Service Bulletin

Bulletin No.: 17-NA-357

Subject: Noise or Malfunction of Trim Door on Broken Quarter Upper Trim Panel, Possible Convertible Top Inoperative

Brand:	Model:	Model Year:		VIN:		Engine:	Transmission:
		from	to	from	to		
Chevrolet	Camaro Convertible	2016	2023	—	—	All	All

4889569

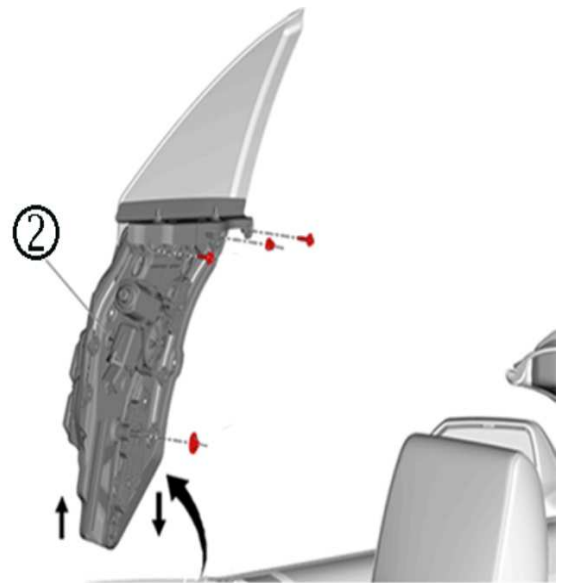
Note: For vehicles built prior to February 14, 2017, it will also be necessary to replace the window regulator in addition to the quarter upper trim panel to accommodate the added 3rd clip design.

Important: Under no circumstances should the 3rd clip be removed from the quarter upper trim panel.

- For vehicles built February 14, 2017 and after, replace the quarter upper trim panel (1). Refer to *Quarter Upper Trim Panel Replacement* in SI.

- For vehicles built prior to February 14, 2017, replace the quarter upper trim panel AND the quarter window regulator (2). Refer to *Quarter Window Regulator Replacement* in SI.
